HISTORIC MOBILE LLC CONGRESS SUBDIVISION

APPLICATION NUMBER	2	DATE	December 1, 2022
APPLICANT	Historic Mobile LLC Congress Subdivision		
REQUEST	Subdivision

DETAIL SITE PLAN

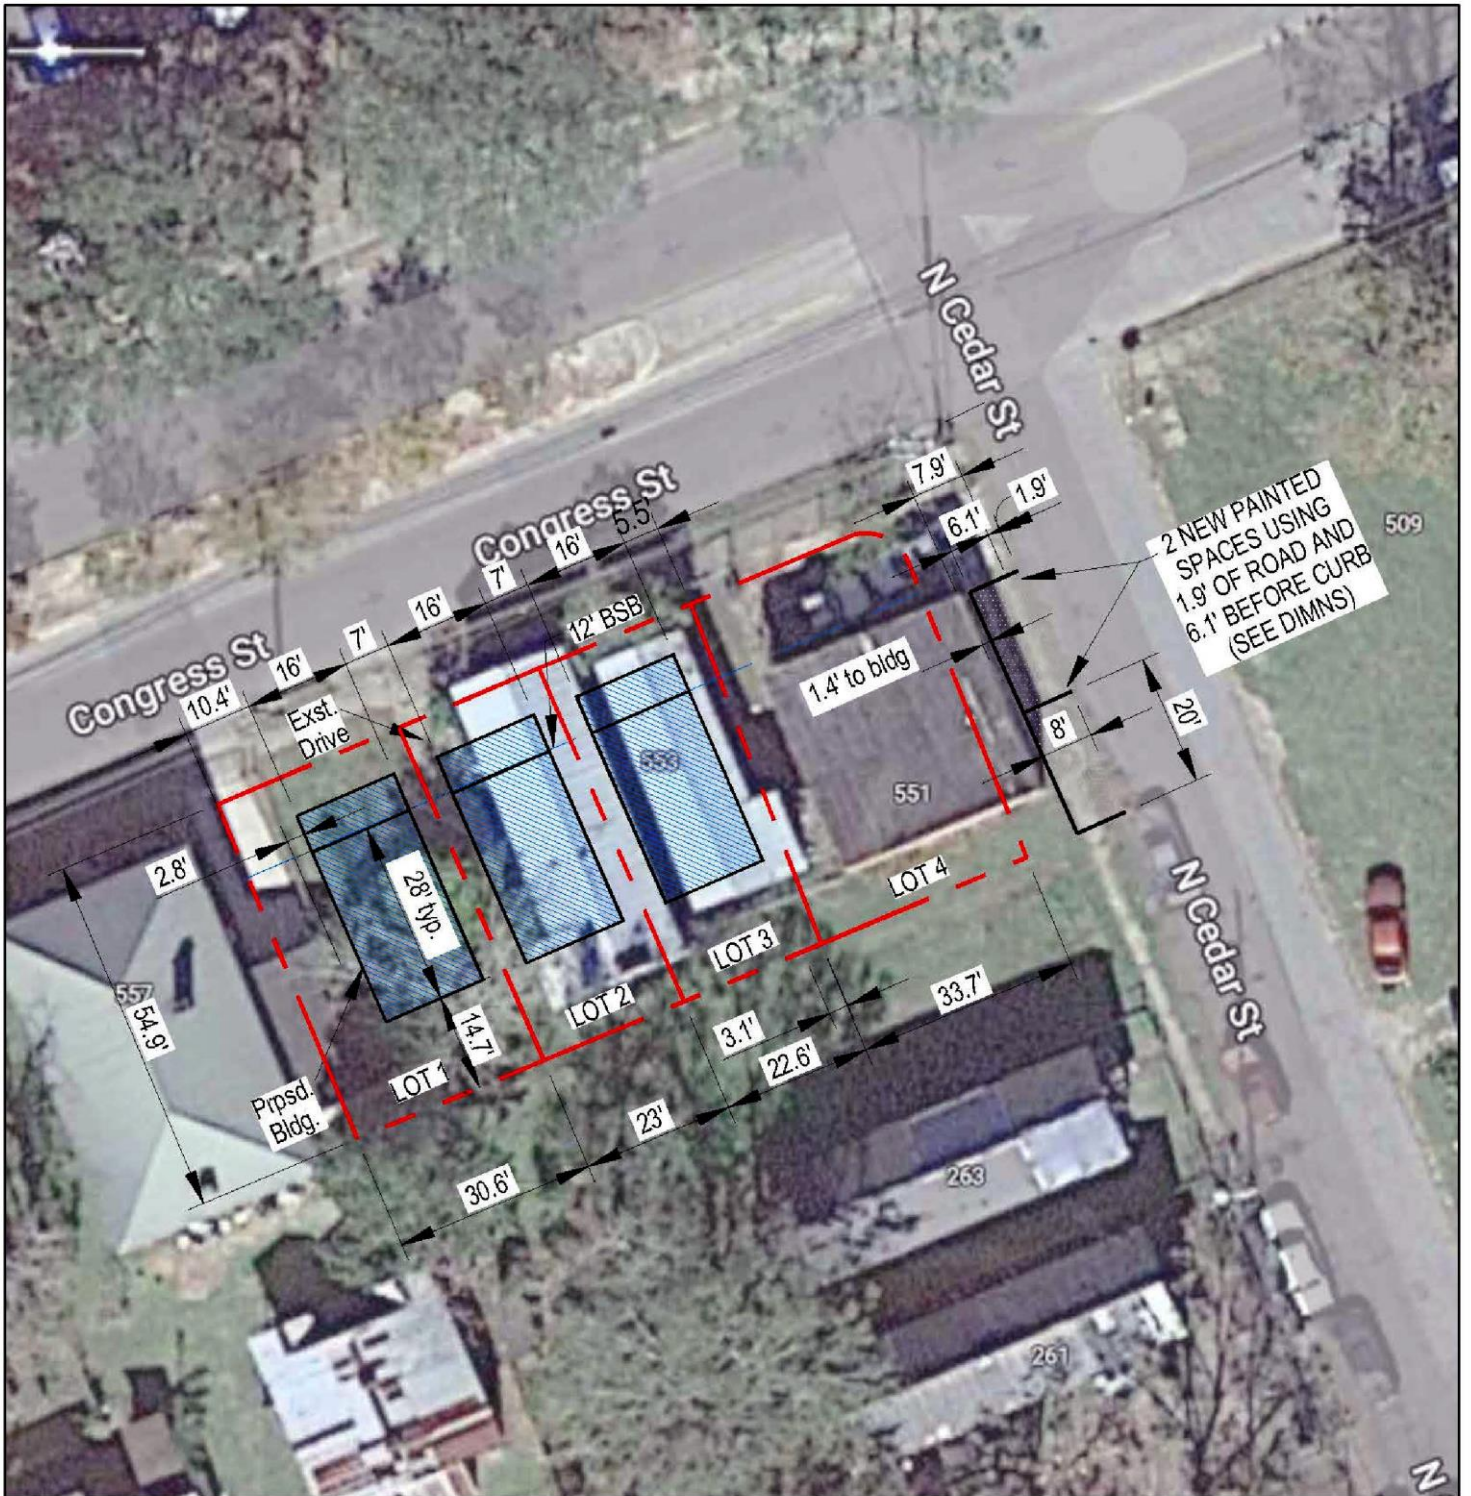
- B. Provide and label the monument set or found at each subdivision corner.
- C. Show and label the MFFE on each lot that contains an AE, V, or X (shaded) flood zone designation. The BFE is 11.

- D. Clarify the status of the ROW at the NE corner of LOT D. The plan view indicates that there is ROW that is to be vacated and the written description mentions "...former road right-f-way...". If necessary provide additional details showing the existing and proposed ROW.

- E. Provide the recording information for any vacated Rights-Of-Way and easements.
- F. Add a note to the SUBDIVISION PLAT stating that as shown on the 1984 aerial photo (FLIGHT 30 - #70) LOTS A, B, C, and D will share the historical credit of existing (1984) impervious area towards stormwater detention requirement per Mobile City Code, Chapter 17, Storm Water Management and Flood Control) as follows: LOT A – NONE, LOT B – 1,100 sf, LOT 3 – NONE, AND LOT 4 – 1,300 sf.

The subject site consists of Lots 1, 2 and 3, Raye McKinley Subdivision, approved by the Commission in 2010. A condition of that approval was the dedication of a ten-foot (10') radius curve at the intersection of Congress Street and North Cedar Street. The preliminary plat indicates that dedication is to be vacated and incorporated within the current subdivision. Therefore, if determined by the City and Traffic Engineering that this right-of-way is no longer required, the Vacation process should be completed prior to signing the Final Plat, if approved.

The proposed lot fronts Congress Street and North Cedar Street which are minor streets with curb and gutter each requiring a 50-foot right-of-way width. Congress Street is labeled on the plat with a compliant 80-foot right-of-way, and North Cedar Street is labeled with a compliant 50-foot right-of-way. Therefore, no frontage dedication would be required. The right-of-way widths of both streets should be retained on the Final Plat, if approved. The primary street frontage should be designated on the Final Plat, as per Section 64-3.I.8(a) of the Zoning Ordinance.

Per Section 64-3.I.8.(d), in a T-4 Sub-district, the DDD allows a twelve-foot maximum setback along the primary street frontage. Proposed Lots B and C contain dwellings within the allowable setback range which are proposed to be removed from the site, and proposed Lot A is currently vacant. Proposed Lot D currently has a commercial building situated beyond the allowable 12-foot maximum setback and would be considered legal nonconforming. A note should be required on the Final Plat stating that the site is subject to compliance with the setback requirements of the DDD. As this differs from the standard 25-foot minimum setback required by Section V.D.9. of the Subdivision Regulations, this section will need to be waived, if approved.

As on the preliminary plat, the lot size labels in both square feet and acres should be retained on the Final Plat, or a table should be furnished on the Final Plat providing the same information. While generally in keeping with smaller lots in the area, the proposed lots are less than the 7,200 square feet required by Section V.D.2. of the Subdivision Regulations, thus a waiver of that section will be required, if approved.

Section 64-3.I.11.(c)(3) of the DDD limits the driveway width to 10 feet in width within the front setback in a T-4 Sub-district, and a note should be required on the Final Plat stating such. Moreover, as per Section 64-3.I.11.(c)(5), a maximum of one curb cut per street frontage is allowed per lot, thus a note should be required on the Final Plat stating such, if approved.

- 1) retention of the right-of-way widths of Congress Street and North Cedar Street on the Final Plat;
- 2) if approved by both City Engineering and Traffic Engineering, completion of the Vacation process for the previously dedicated portion of public right-of-way at the Southwest corner of Congress Street and North Cedar Street to be incorporated into the subdivision prior to signing the Final Plat;

- 3) placement of a note on the Final Plat stating that the site is subject to compliance with the setback requirements of the DDD;
- 4) retention of the lot size labels in both square feet and acres on the Final Plat, or the furnishing of a table on the Final Plat providing the same information;

- 5) designation of the primary frontage on the Final Plat;
- 6) placement of a note on the Final Plat stating that the driveway width is limited to 10 feet within the front setback;

- 7) placement of a note on the Final Plat stating that each lot is limited to one curb cut per street frontage;
- 8) compliance with the Engineering comments: *(FINAL PLAT COMMENTS (should be addressed prior to submitting the FINAL PLAT for review and/or signature by the City Engineer): A. Provide all of the required information on the SUBDIVISION PLAT (i.e. signature blocks, signatures, certification statements, written legal description, required notes, legend, scale, bearings and distances) that is required by the current Alabama State Board of Licensure for Professional Engineers and Land Surveyors. B. Provide and label the monument set or found at each subdivision corner. C. Show and label the MFFE on each lot that contains an AE, V, or X (shaded) flood zone designation. The BFE is 11. D. Clarify the status of the ROW at the NE corner of LOT D. The plan view indicates that there is ROW that is to be vacated and the written description mentions "...former road right-f-way...". If necessary provide additional details showing the existing and proposed ROW. E. Provide the recording information for any vacated Rights-Of-Way and easements. F. Add a note to the SUBDIVISION PLAT stating that as shown on the 1984 aerial photo (FLIGHT 30 - #70) LOTS A, B, C, and D will share the*
